CONTRACTOR
CHANGE ORDER

New Fortville Elementary
Project #01123202

Change Order Number: 002

Potential Change Item: PCI #89 – RFI #173 - Adding Kickers to Bent Plate

1 E29 ROOF FRAMING PLAN - UNIT A (SEQ. 9)

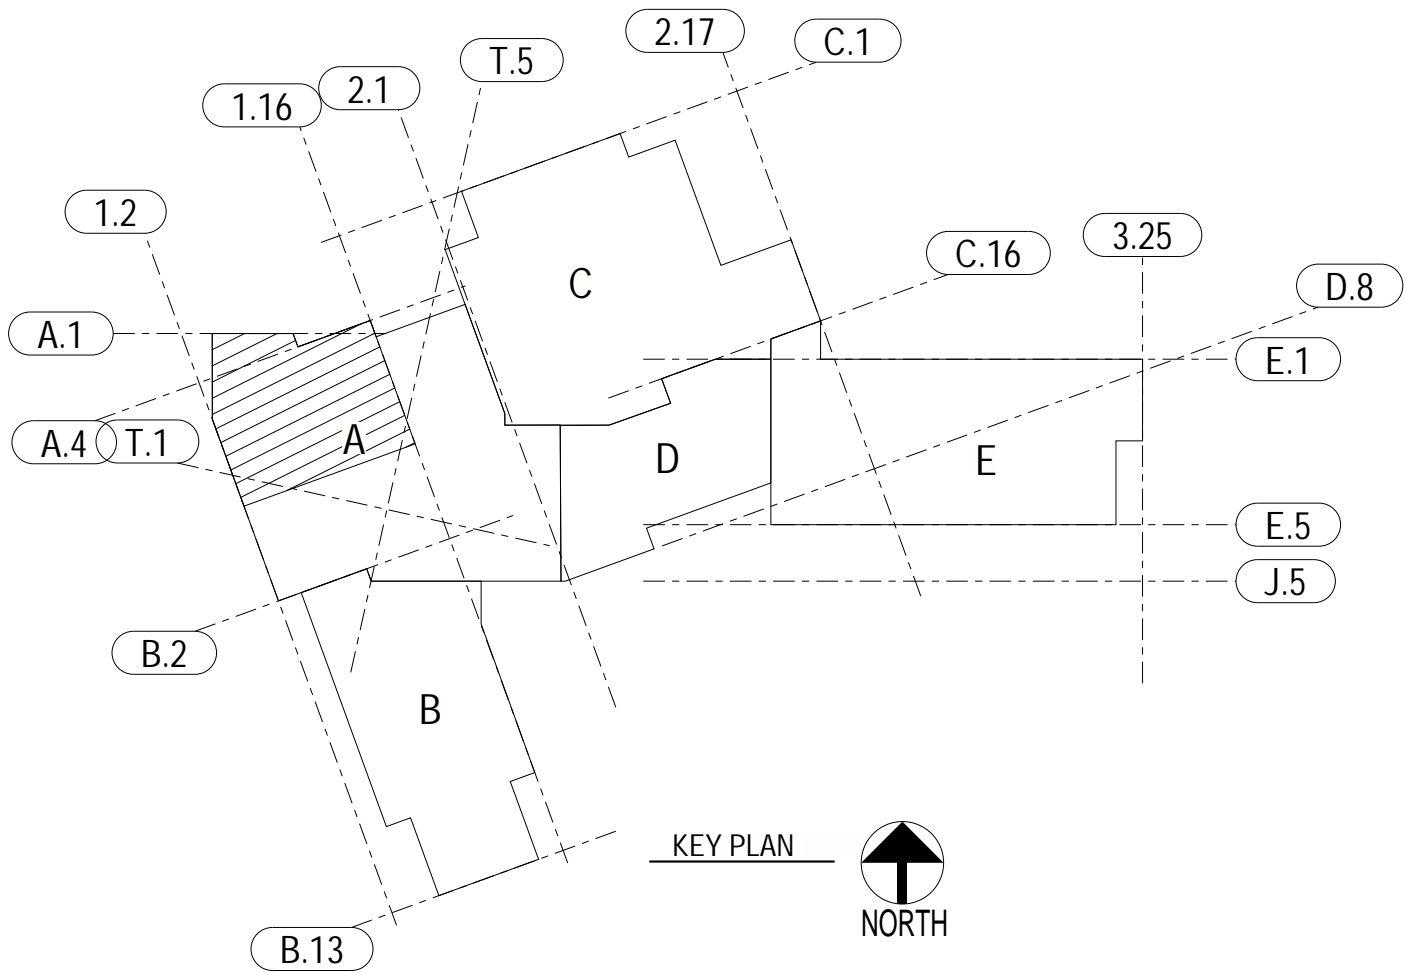
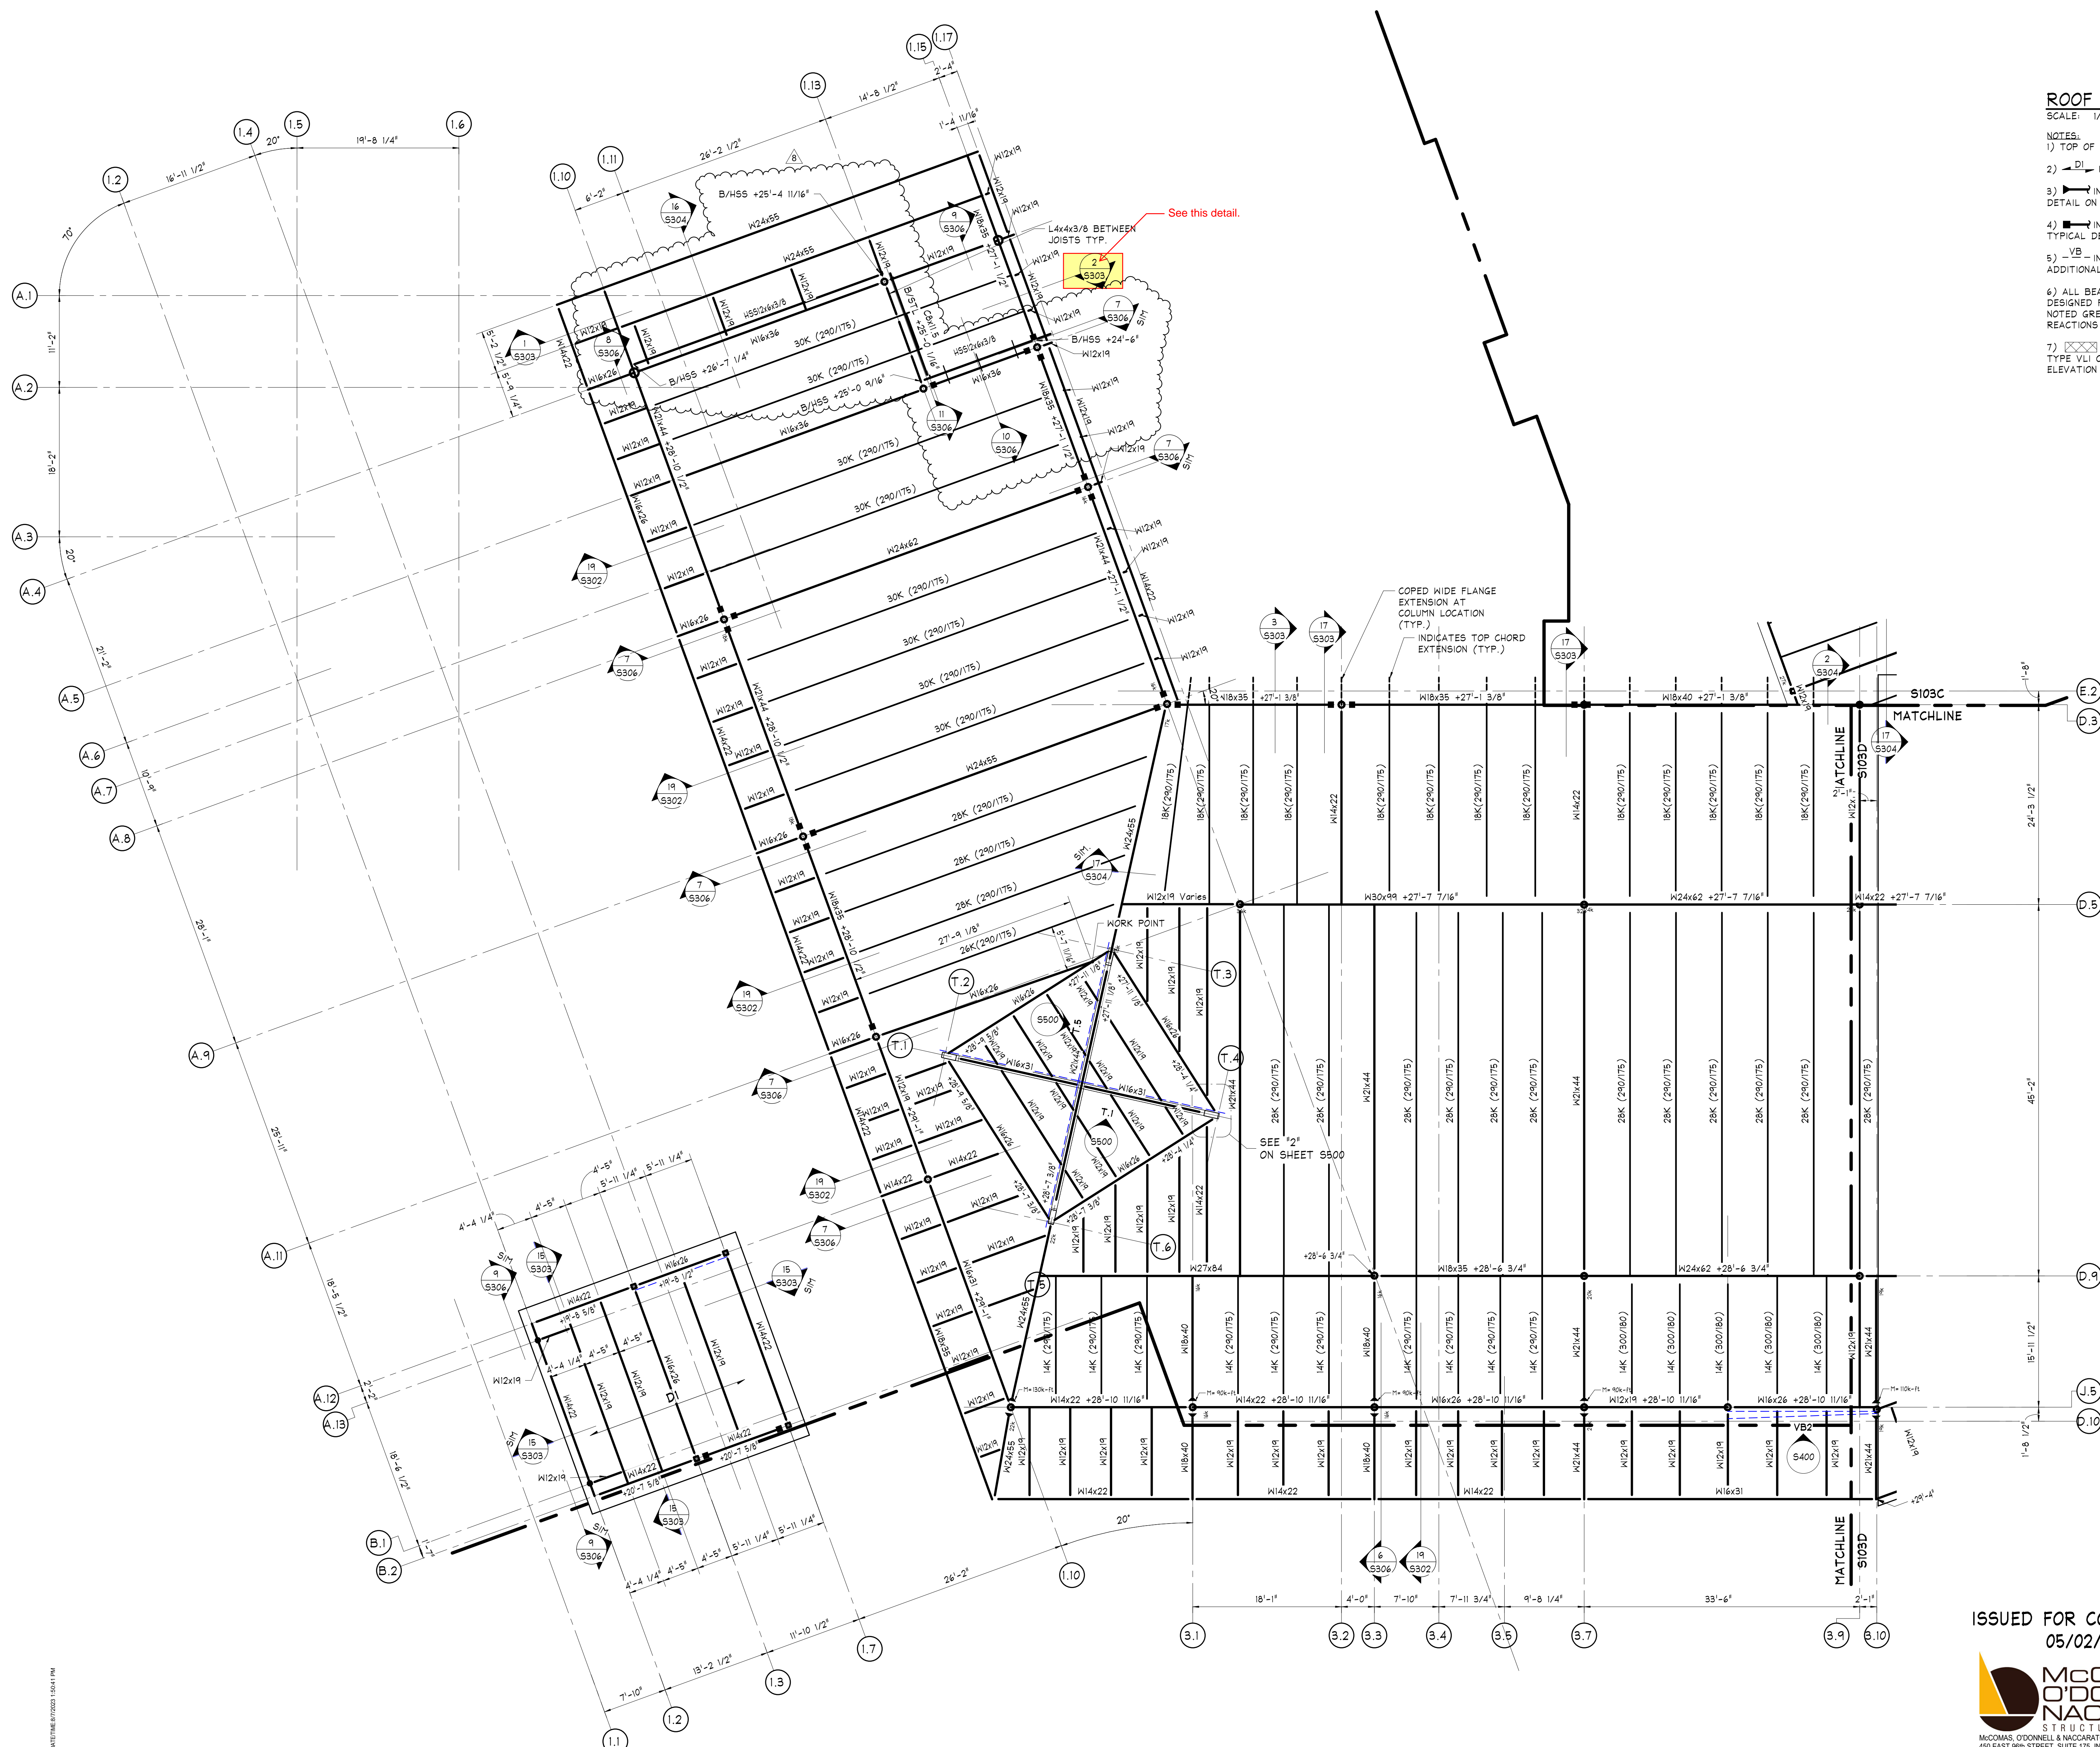
Subject **Unit A – Add Angle Kickers to Support Deck Edge Bent Plate**

Please provide if it's acceptable to add L3x3 kickers spaced every 3' O.C. and 2' from the ends of bent plates.

On 8/25/2023, ISF RFI#083 came back confirming that the edge of deck is to be 2' 11-1/4" from gridline 1.15. During erection, my erector noticed that when placing the bent plates at these (7) locations, the beam is wanting to roll and that the bent plate is flexing down where it's overhanging off of the beam.

Proposed construction is acceptable. add kickers from edge of plate down to bottom of W12 beam, and from bottom of W12 beam to top flange of adjacent beam on grid 1.15. See page 4 for clarification in green.

1
E29 ROOF FRAMING PLAN - UNIT A (SEQ. 9)

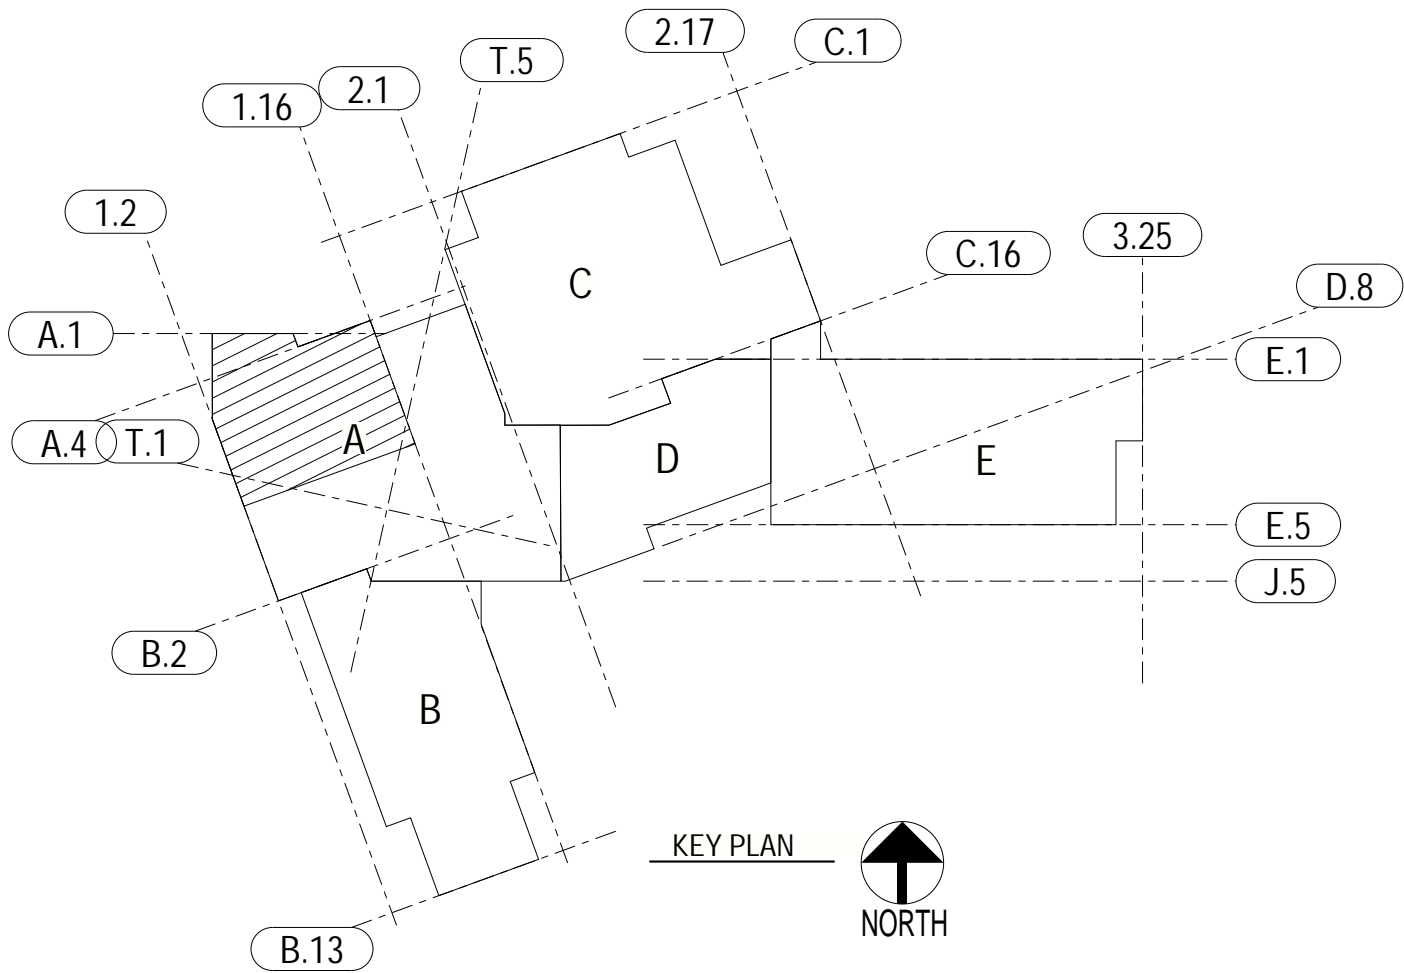
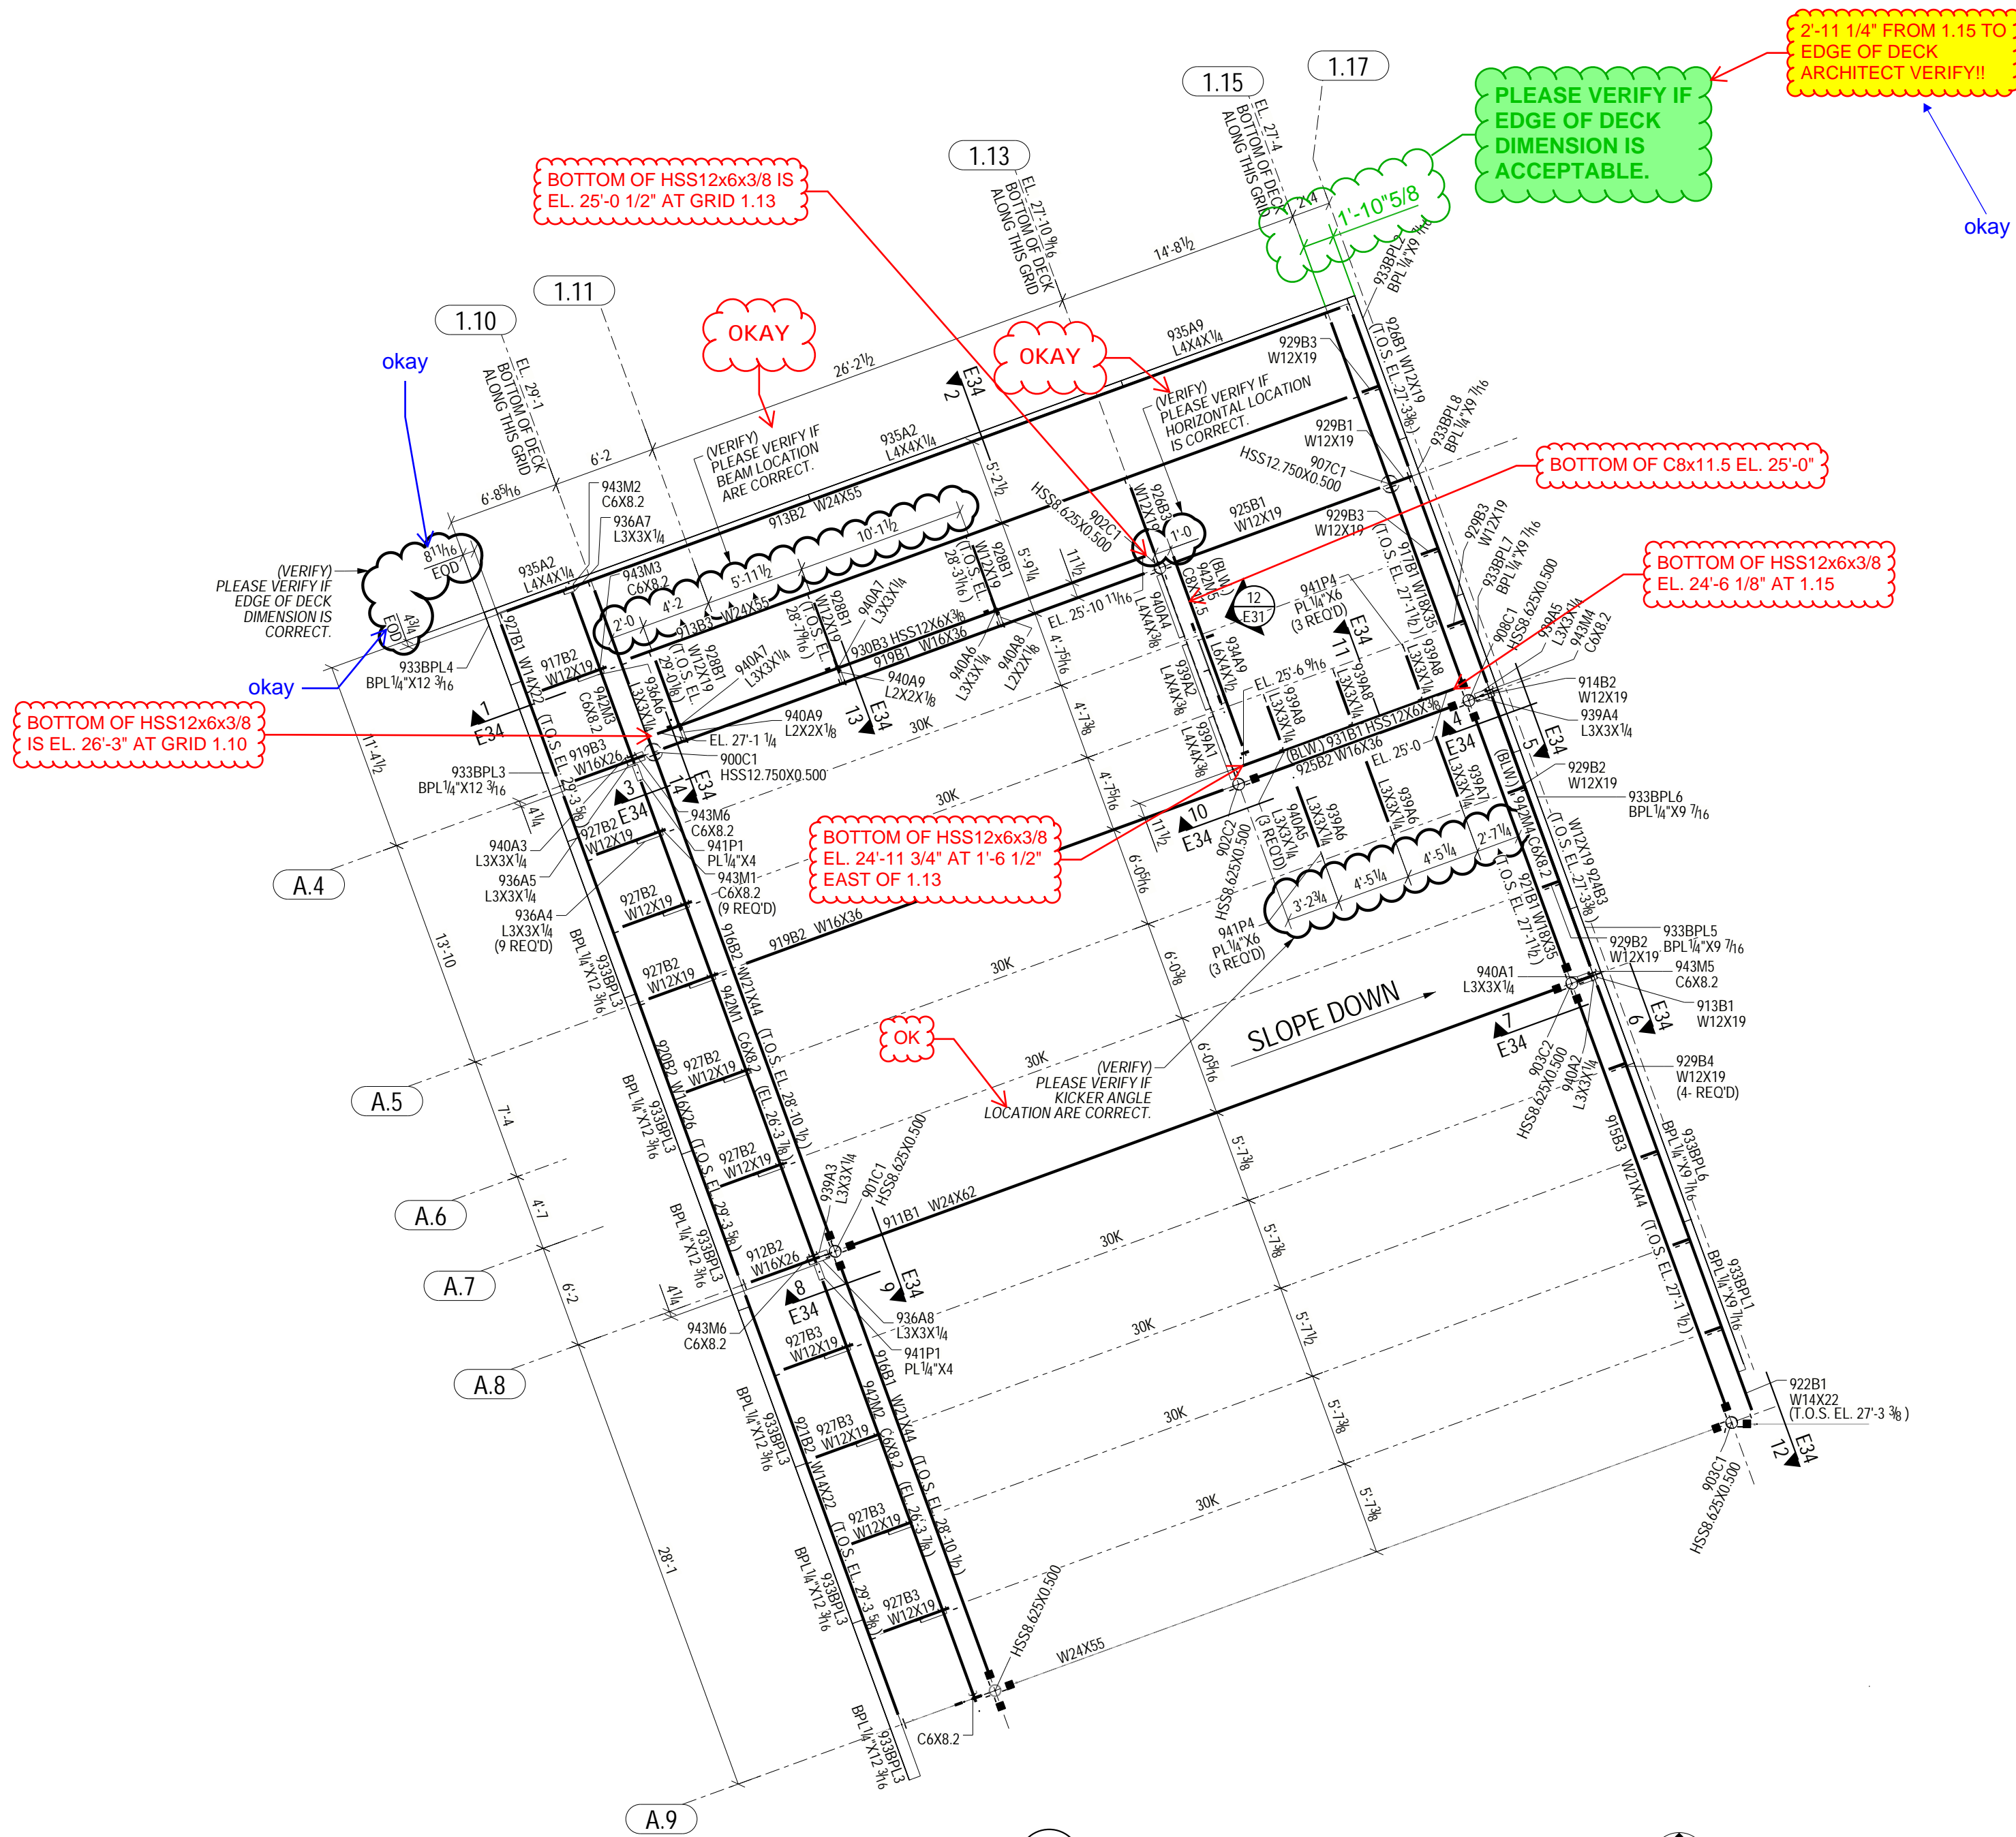
Subject **Sequence 9 and 10 BFA Clarifications**

Please see attached PDF's and verify questions marked up in green.

Comments in red with yellow infill on the attached.

Comments in blue on the attached.
